Memo

To: Anthony Scholes
From: Buju (Burcu) Can Cetin, Conservation Officer
Date: 18/09/2025
Re: Conservation Officer response

Application Number: PL/24/1155

Address: JOHN LEWIS CUSTOMER COLLECTION POINT, CROSSLAND ROAD, READING, RG1 2HT

From Page 12 of the Planning Statement Addendum

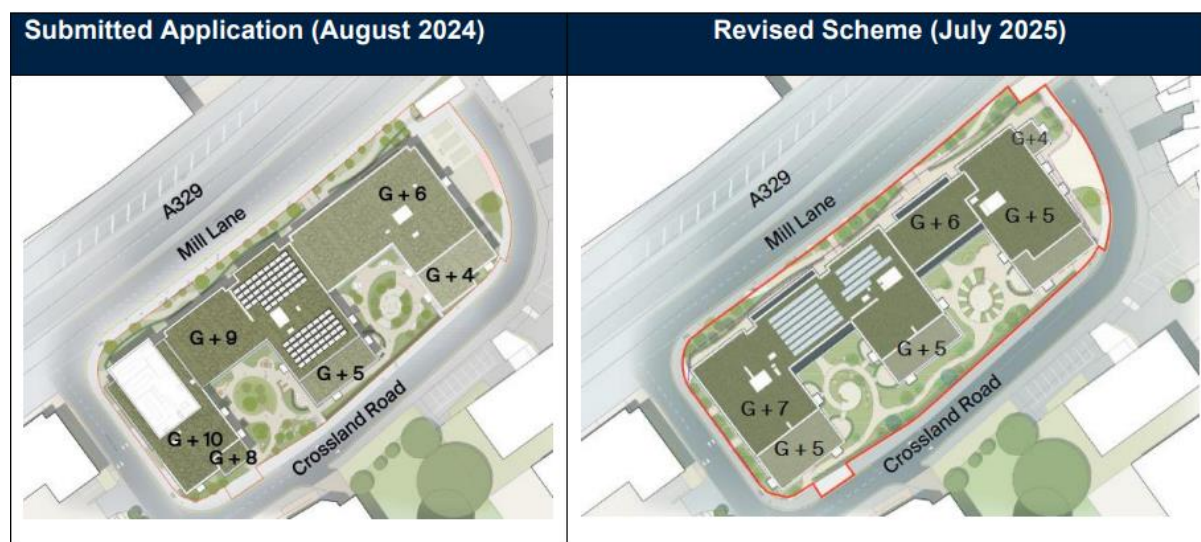
The Planning Statement Addendum explains more about the Revised Scheme, advising that it has 5 to 8 storeys, more stepped down, and the addition of a 'nib' for better transition to the conservation area (as illustrated below), all of which are positives of the latest proposal.

Proposed Ground Floor Plan- possible continuous public use and green approach is shown in red arrows

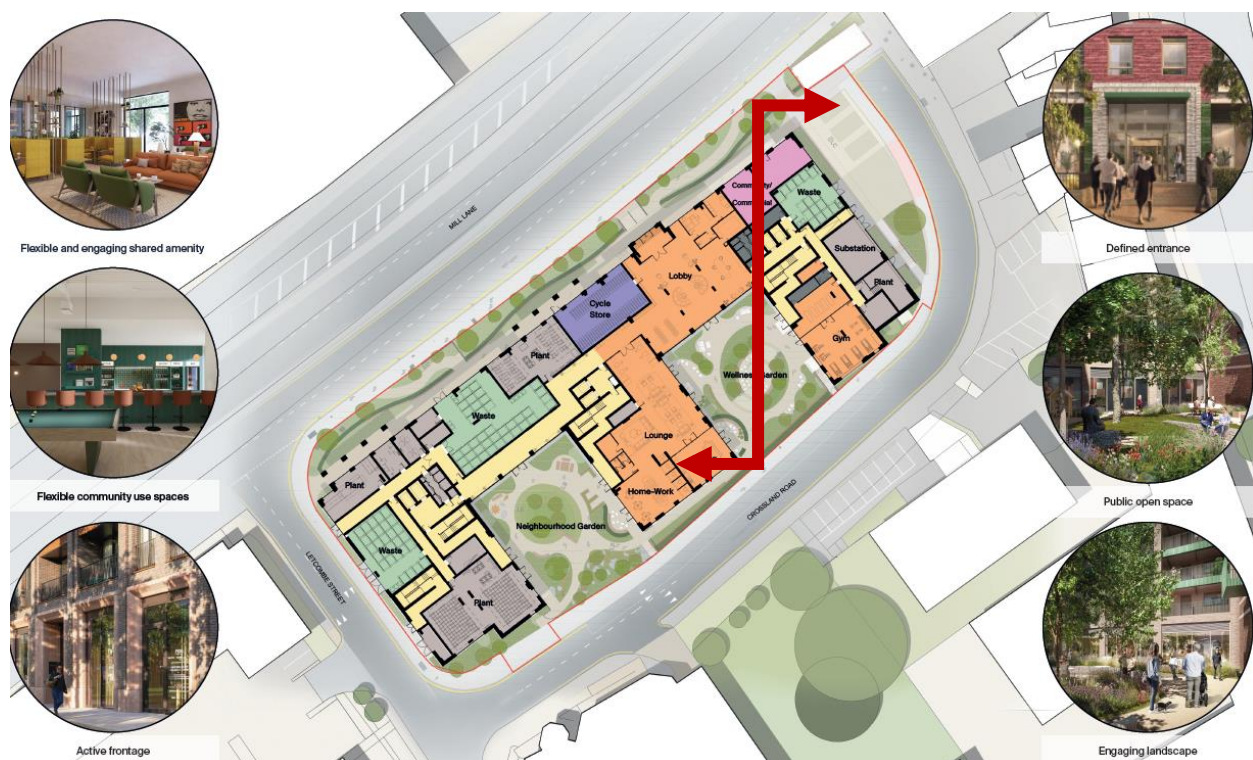
In relation to the proposed ground plan, when it is analysed in detail – although I understand and appreciate the scheme creating community/public uses with the aim of active frontage, I cannot read that approach on the proposed ground floor uses. To the northeast of the application site, close/opposite to the central club, there is a designed community/commercial space. Other than that, to the front of the proposed block(s)/to the north, there is not any continuous or active use that would pay attention and be counted as a public interest. Next to the commercial use lobby, the cycle store, plant, waste, and plant are positioned, respectively.

I find the proposed tree line and landscaping to the front and the neighbouring garden to the rear to be among the strongest features of the proposed development, which directly relates to the surrounding environment, human scale, and heritage assets. However, the connections and 'active' use purpose get weaker given their oppressed locations. As the proposed scheme would have a very big impact on the environment in which it sits, there should have been a clear and distinctive design for public use and benefits. The use of green elements and natural features has been encouraged to soften the impact of the height of the blocks and provide a good transition. Therefore, further consideration should have been given to the design of publicly used spaces, and the ground floor plan should support their 'active' use.

For instance, community/commercial use should be enlarged and connected to other public uses, such as the neighbouring garden. To do so, the proposed wellness garden for the residents should be a neighbouring garden to enhance the public use of the scheme. It is obvious that the proposed block in the middle would have harmful impacts on the setting of the listed Quaker's Meeting House. Surprisingly, no mitigation measures have been proposed for this impact. I highly recommend extending the neighbouring garden or natural features to the rear of this block so that it would reduce the impact of the scale and height of the proposed development as well as show a continuity of public use or a green approach to the scheme.

Proposed Ground Floor Uses (page 70, Design and Access Statement): weak and problematic relations that would result in harmful impact on the historic environment is shown in red arrows

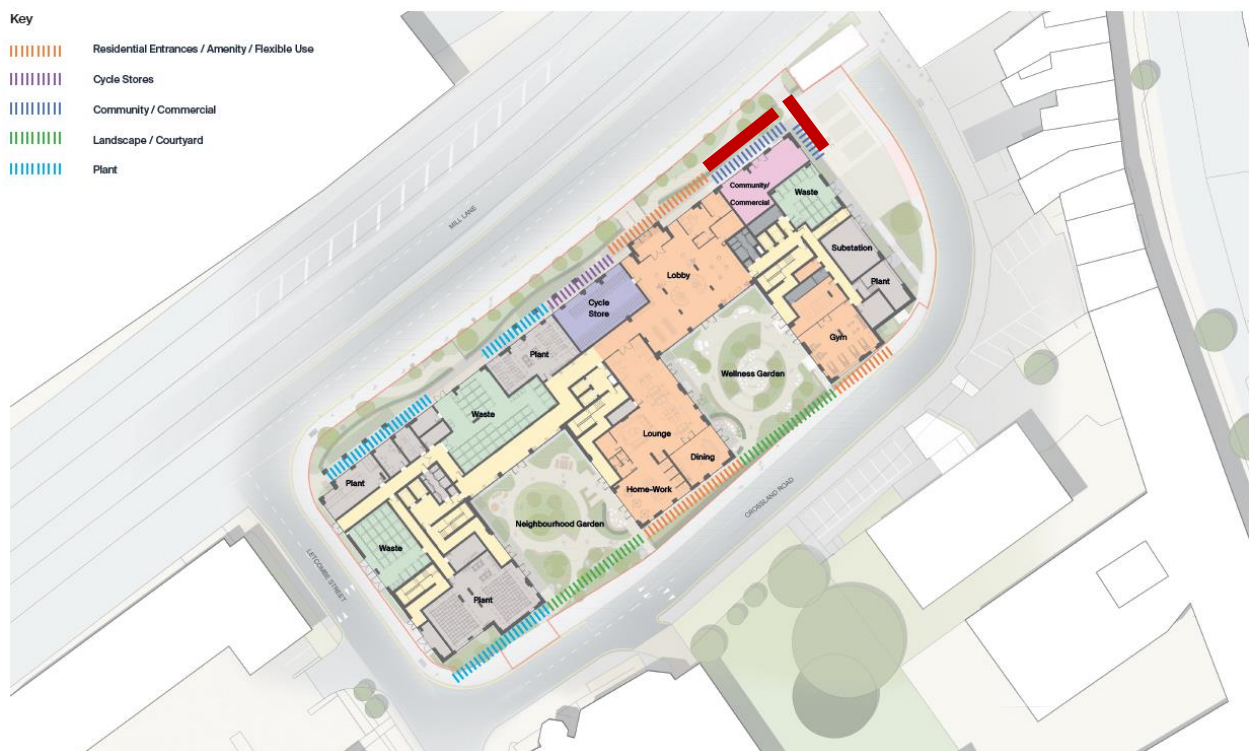
Proposed Ground Floor Plan – Active Frontage: Community/Commercial use is emphasised by red lines – their percentage within the proposed scheme is very low

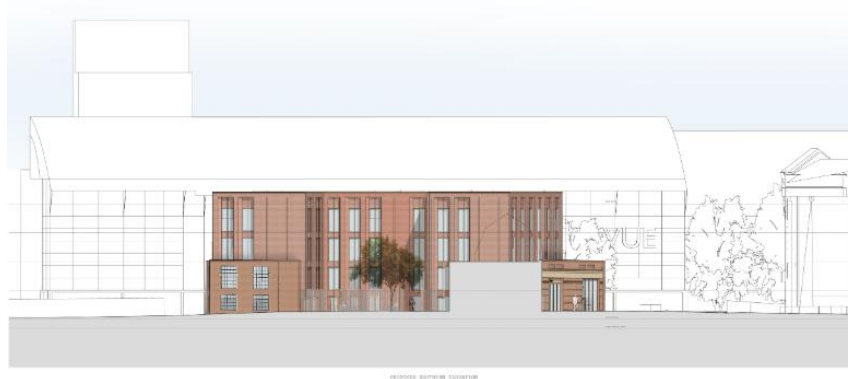
Proposed North Elevation (page 111, Design and Access Statement) – This elevation would face the Oracle carpark. The tree line to the front and use of high quality materials would make the site more attractive than the existing appearance. However, in terms of height and scale, there would be a huge difference of height between the proposed blocks and neighbouring character areas. The block with the lowest height would have 7 storeys, next to it would be 4 storey new Central Club building (below) and further 2-3 storeys listed building and buildings of townscape merit within the conservation area. 11 storey block (the highest block) would also sit next to 4-6 storey hotel building. As such, in addition to the further mitigation measures for public uses and green areas, the height of the blocks should be reduced.

Proposed East Elevation (page 112, Design and Access Statement) – This elevation would be next to the Central Club

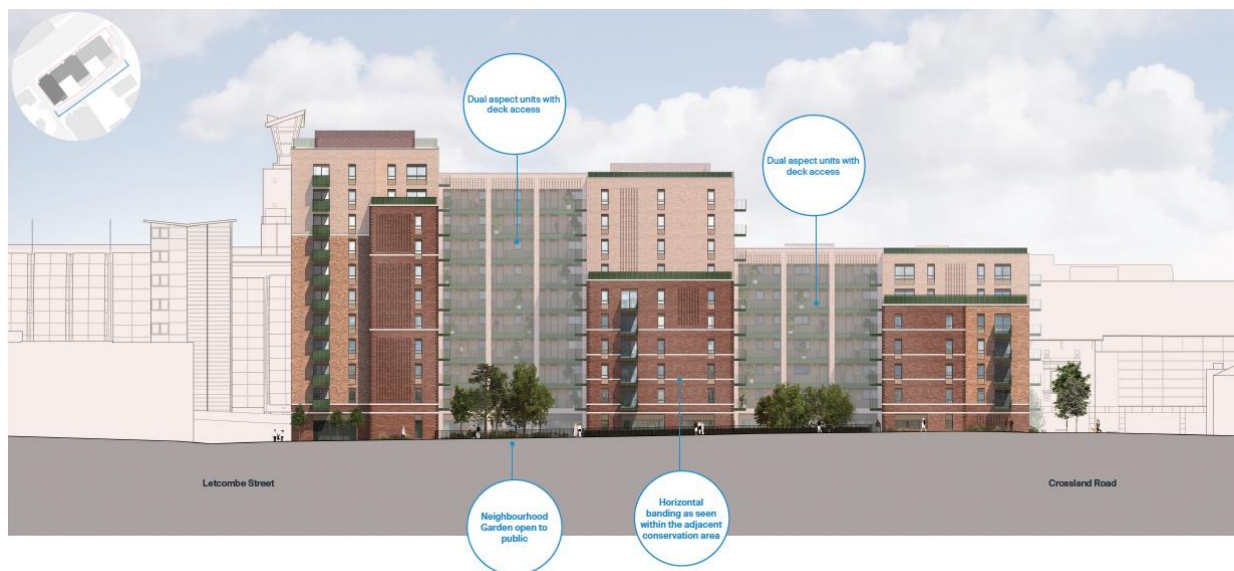
Proposed East Elevation (page 113, Design and Access Statement) – Scale of the proposal compared to the Oracle should be noted – larger than the Oracle

Proposed West Elevation (page 114, Design and Access Statement) – This elevation would face the modern hotel development whose related side elevations are visible in the photo below
- The proposed elevation shows the imposing and dominant characteristics of the proposal
